Subject: Waste Disposal Permit 0131-BA002, Teck-Pogo, Inc.

**WASTE DISPOSAL PERMIT**

**For  
The Pogo Mine**

# **ADEC Response to Comments on the Waste Management Permit issued to the Pogo Mine (ADEC Permit #0131-BA002)**

**Pogo Facilities Map  
and  
Monitoring Locations**

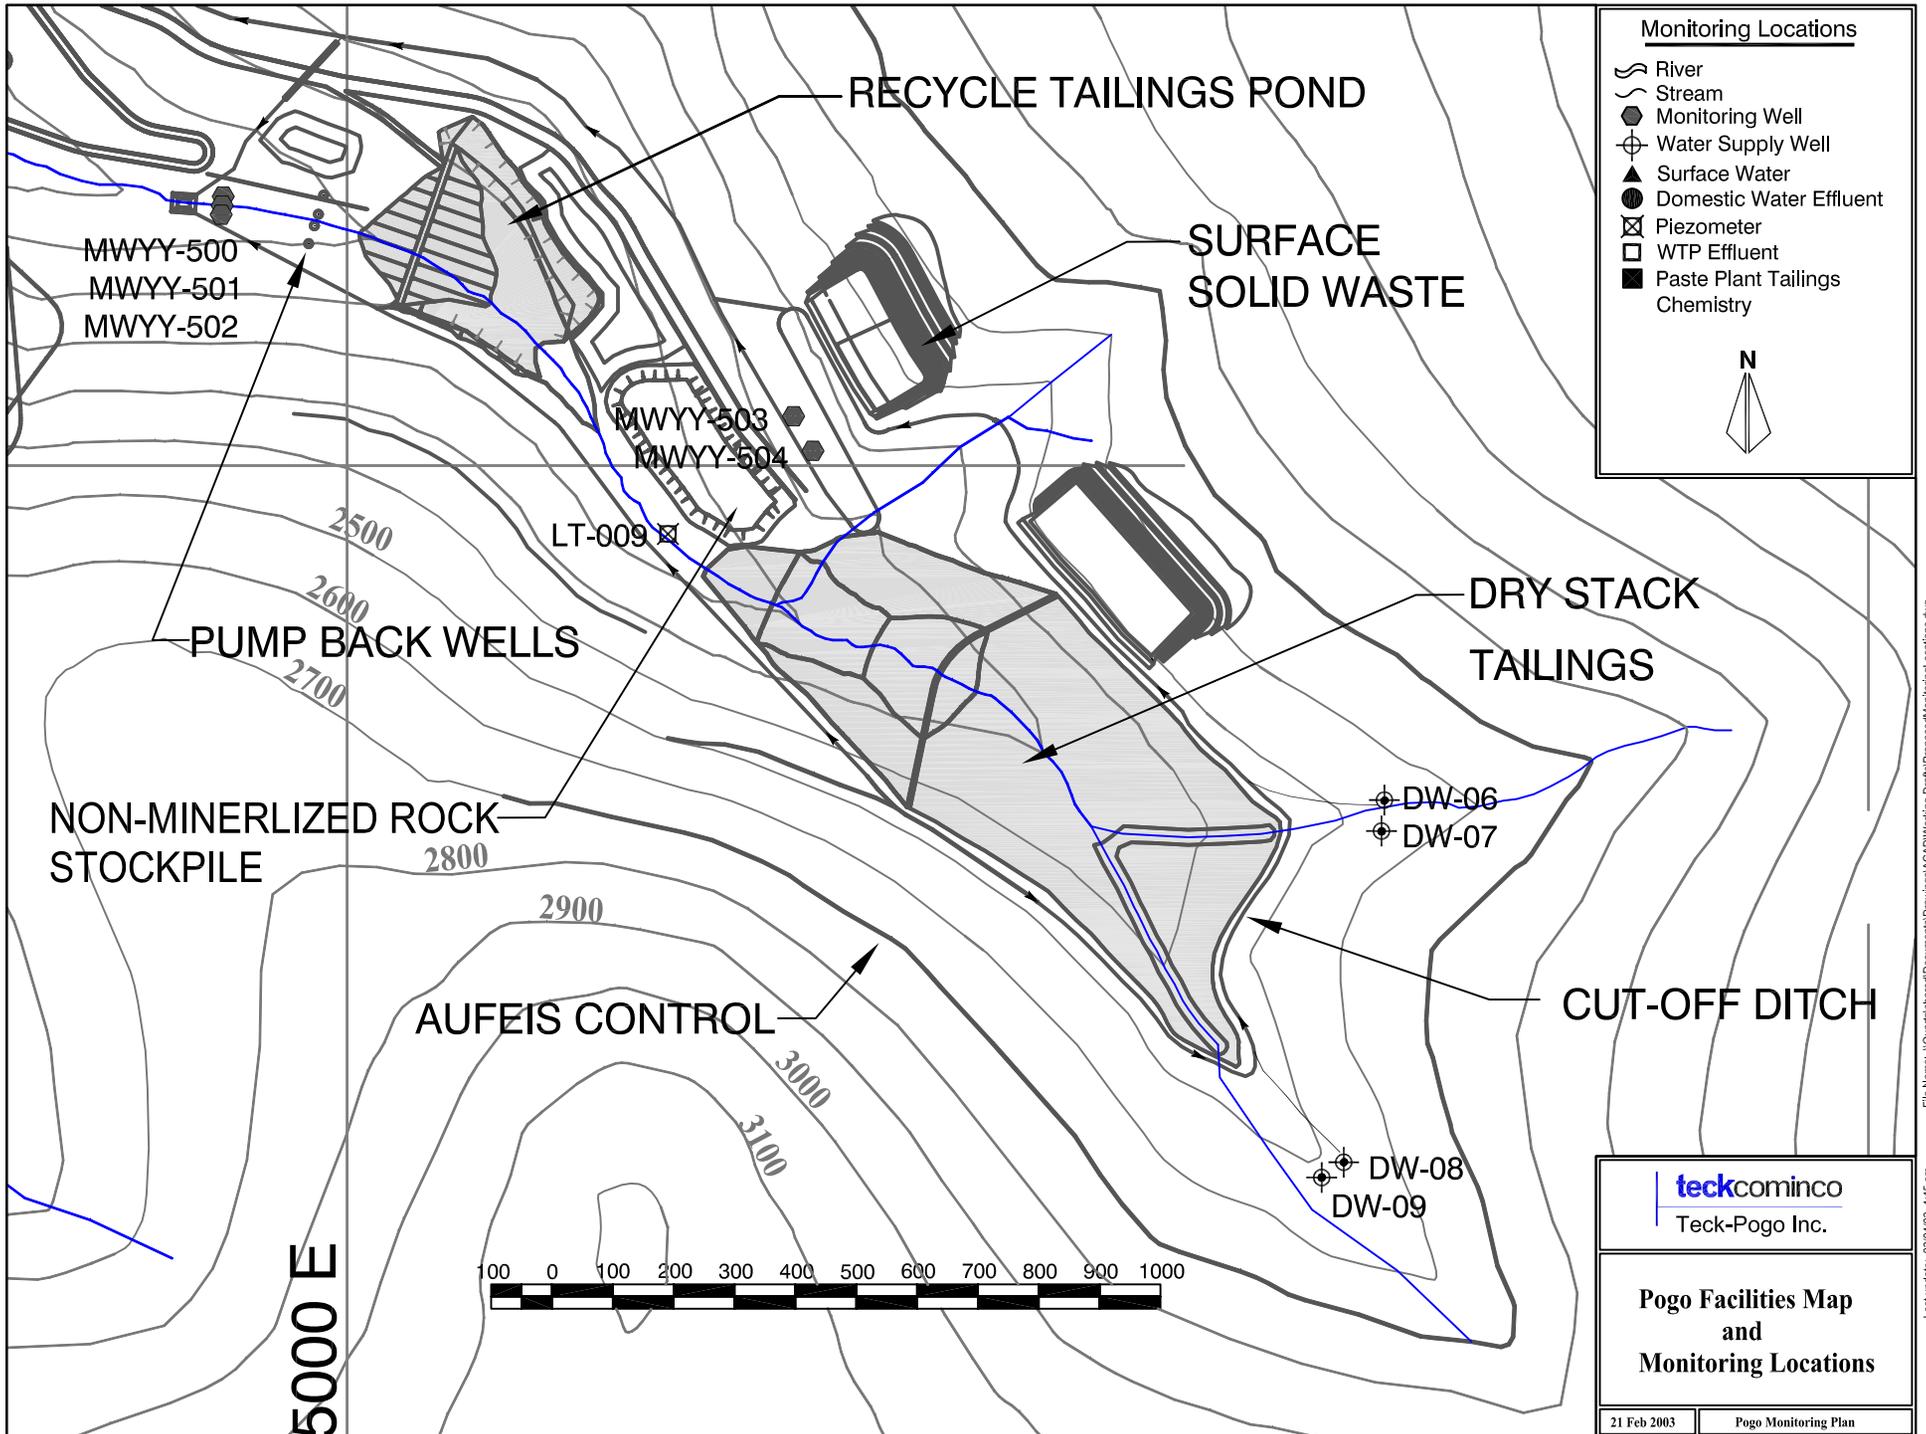
Drawing 3 of the Monitoring Plan shows the Non-Mineralized Stockpile just upstream of the Recycle Tailings Pond. Section 7.4 of the November 2002 Plan of Operations Supplement indicates that this stockpile will store up to 335,000 tons of non-mineralized development rock. The language of Section 1.1.1, 1.1.2 and 1.2.1 should be modified so as to clarify that this non-mineralized stockpile is covered by the permit.

Language has been added to the sections of the final permit listed above to clarify that the non-mineralized stockpile is covered under ADEC Permit #0131-BA002.
